Access Compliance Report

Public Rights-of-Way

(Curb Ramps)

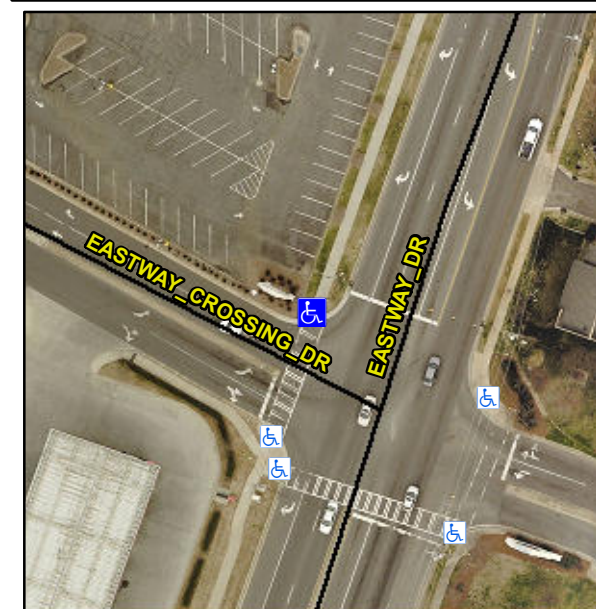
Intersection ID: 30374	Main Street: EASTWAY_CROSSING_DR	Cross Street: EASTWAY_DR	Location: NW
ADA ID: 57DD3662526B	Ramp Type: Directional1	Initial Pass/Fail: Fail	Overall Compliance: No
Codes/Mitigation Info/Possible Solution			Severity Score: 25
			Field Measurements/Component Compliance

R304.2.2, R304.5.3

Remove & Replace Entire Ramp.
